Service Information

CORRECTION TO THE SERVICE MANUAL

CHANGES IN COURSE OF PRODUCTION

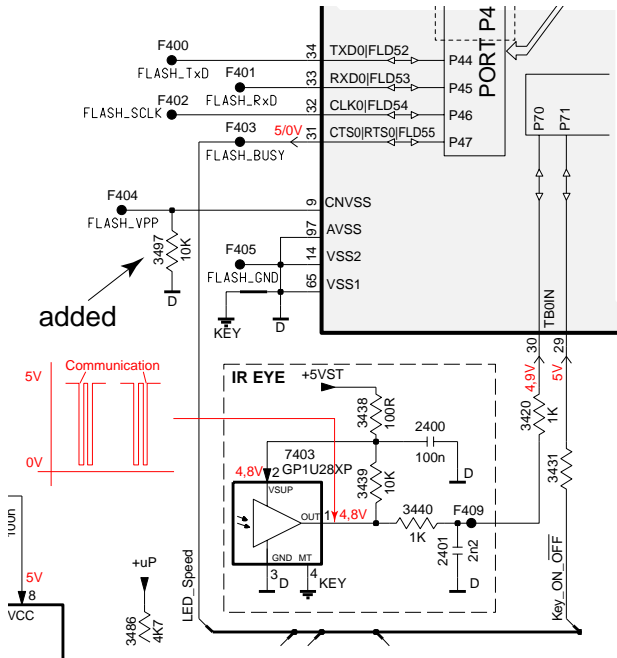
Problem "Disc Recover Mode":

After a power failure during recording, the set enters the "Disc Recover Mode" but it does never return from this mode. The display shows "Disc Recover" even after disconnecting/reconnecting mains.

The faulty disc cannot be removed because the set does not react on any button (i.e. Open/Close).

To remove the faulty disc from the tray proceed as follows:

1. Remove Top Cover
2. Connect mains → set will enter Recover Mode
3. Stop the disc manually until an error message is displayed
4. Press Open/Close

Portion of Display Board layout stage .7 (copperside view)

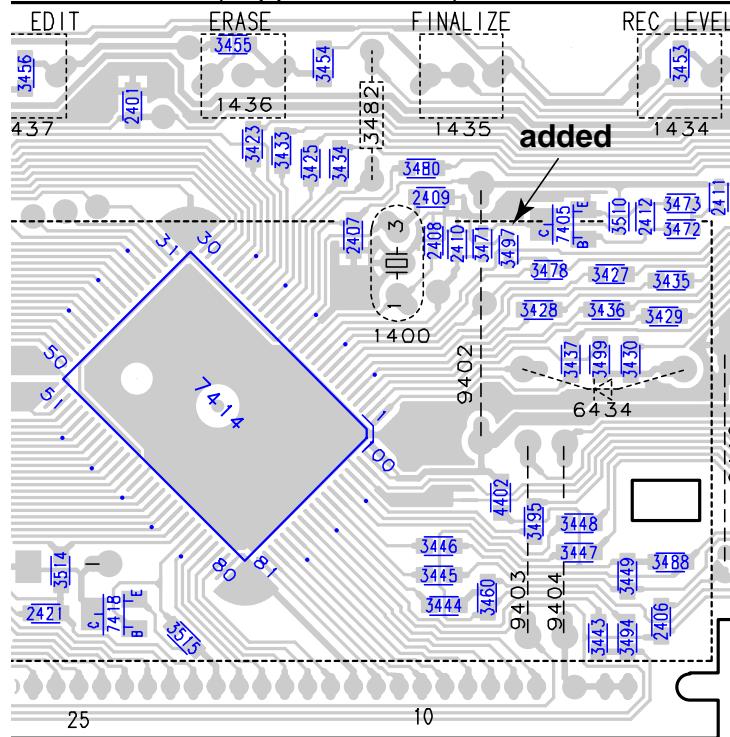
The copper pattern has been changed to layout stage .7.

Reason: To ensure a reliable startup with the flash-version of the µP over all tolerances, resistor 3497 has been added between pin 9 of µP 7414 and ground.

3497© 4822 051 30103 10k 5% 0.06W

SERVICE TESTPROGRAM
CDR MODULE

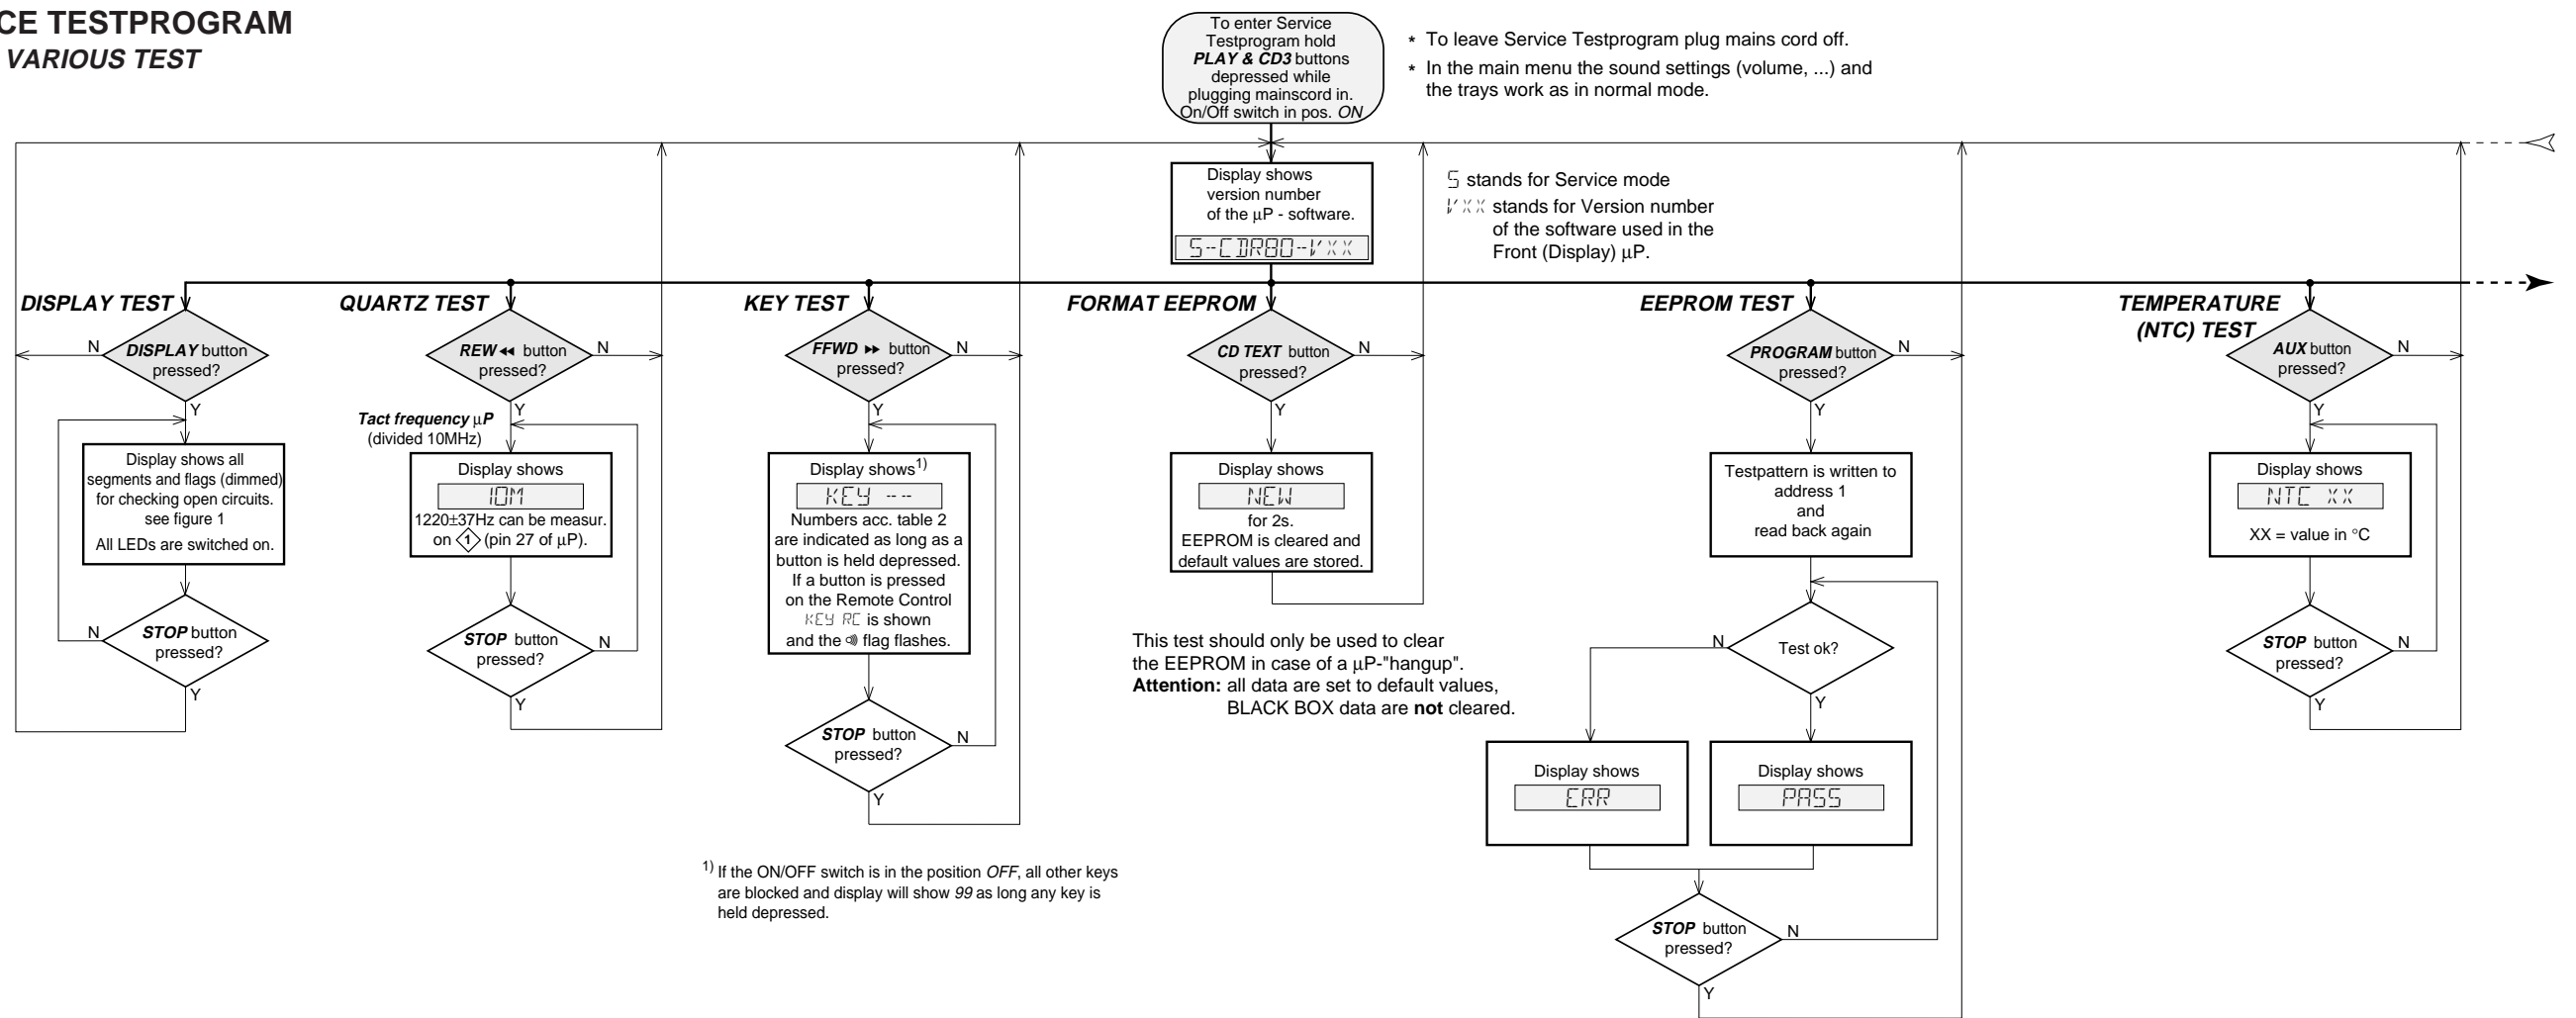
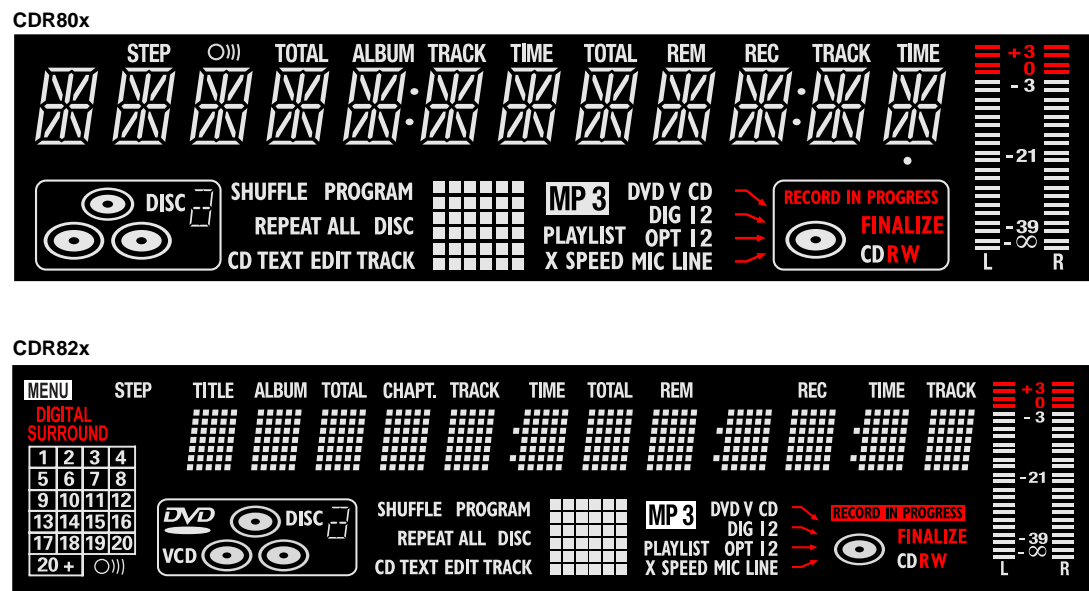
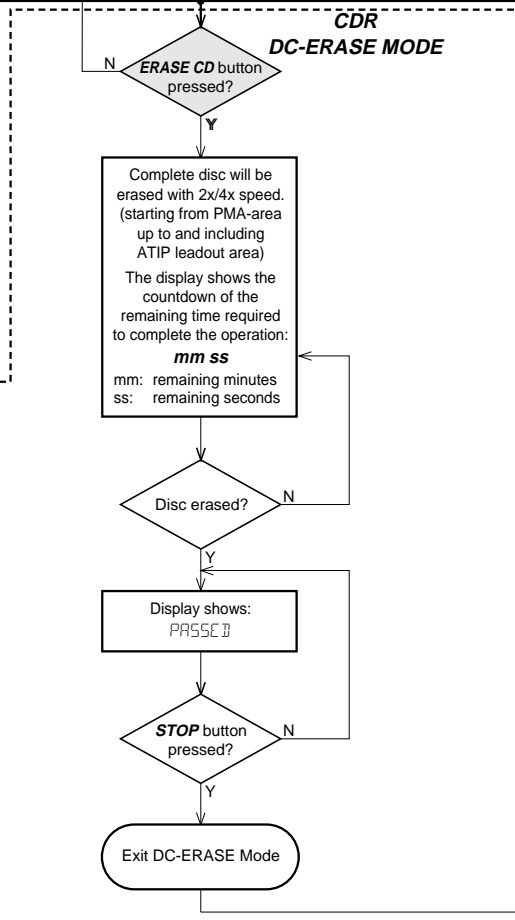
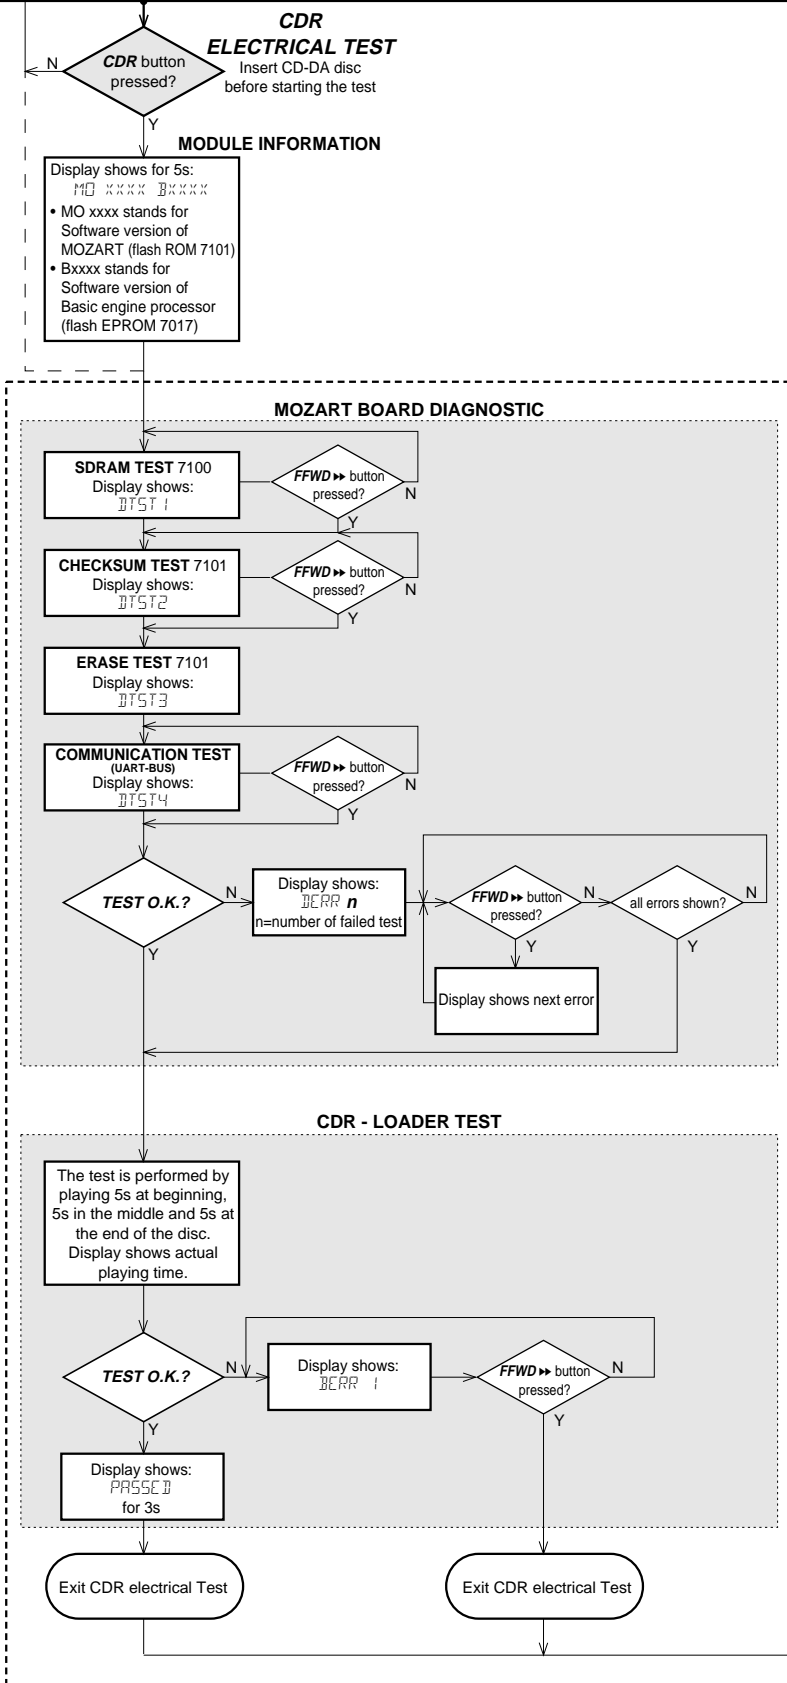
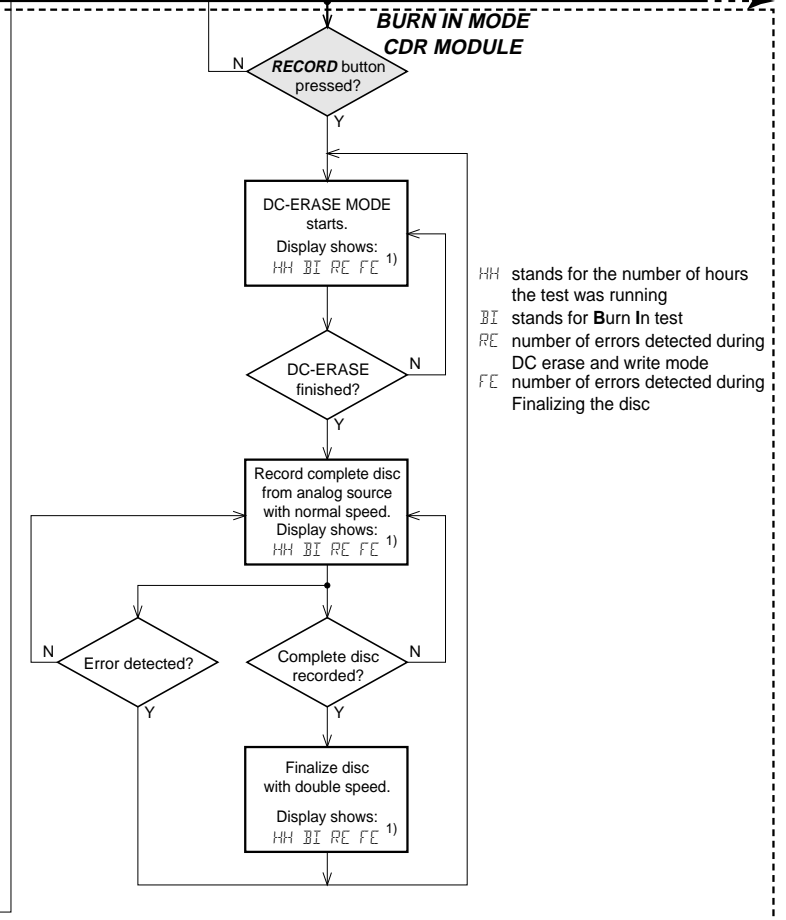
For updated flow charts of the Service Testprogram see attached sheets.

TESTS WORKING FROM FOLLOWING SOFTWARE VERSIONS ONWARDS:
V46, M2021 B0042 CDR80x
V34, M2021 B3201 CDR82x
